**6. ELEVATED WALKWAY | SITE PLAN**

ATTACHMENT 2

112 Lake Street - Kirkland, WA

Continental Properties

**7. KWM TENANT GARBAGE PICK-UP & LOADING ACCESS | SITE PLAN**

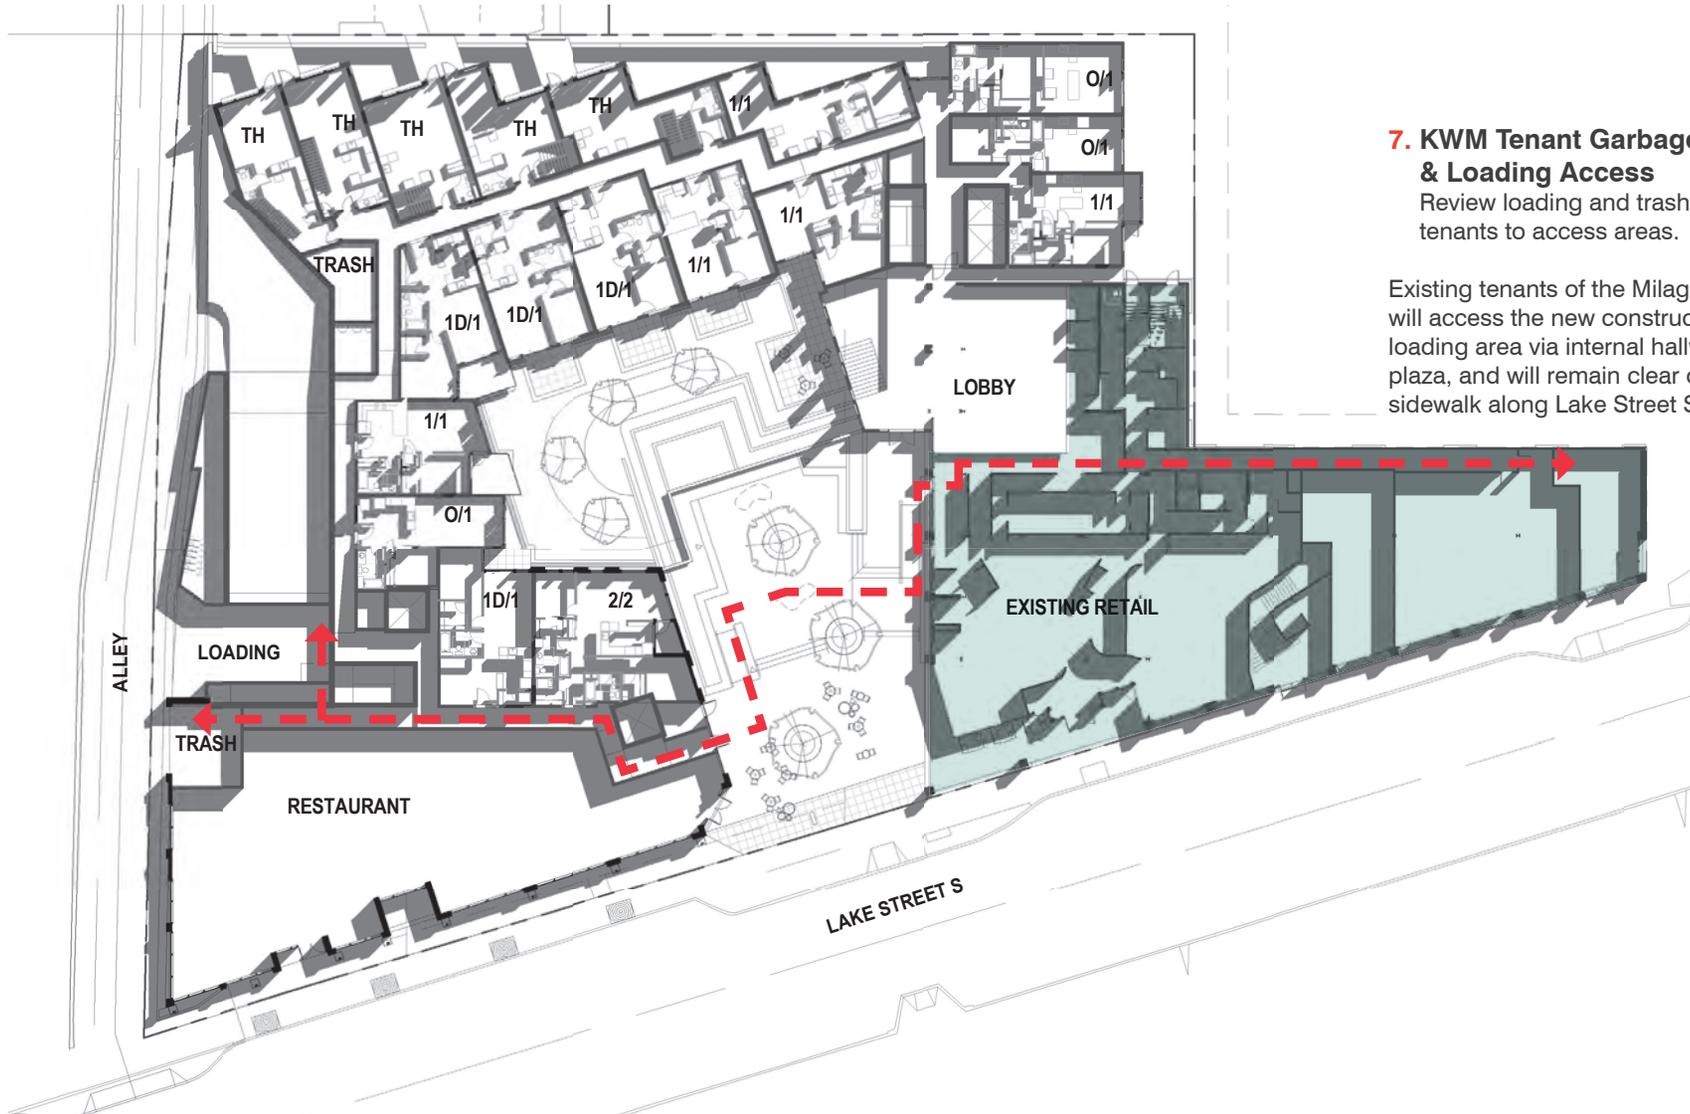
**7. KWM Tenant Garbage Pick-up & Loading Access**

Review loading and trash to allow south tenants to access areas.

Existing tenants of the Milagro Building will access the new construction trash and loading area via internal hallways and the plaza, and will remain clear of the pedestrian sidewalk along Lake Street S.

**1. Reduction of the Lake Street S Upper Level Setback**

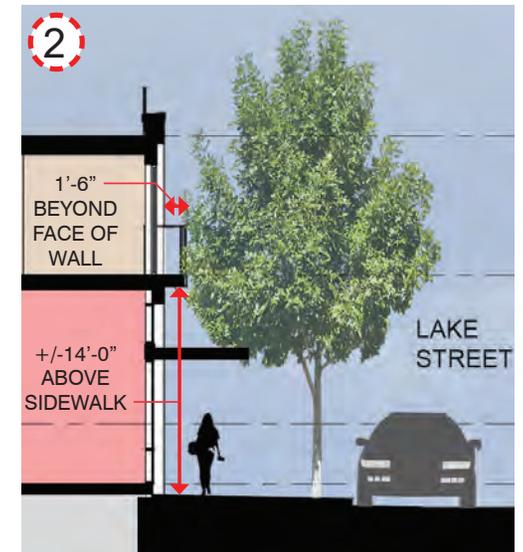
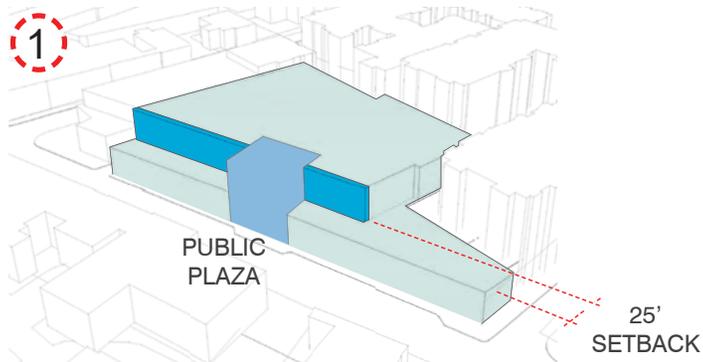
The Design Board is authorized to allow a reduction of the upper level setback by a maximum of 5' by providing an equivalent square footage of public plaza at grade.

Proposed Plaza: +/- 4,600 SF  
 Proposed Encroachment: +/- 1,560 SF  
 (+/- 520 SF at Level 3, 4, and 5)
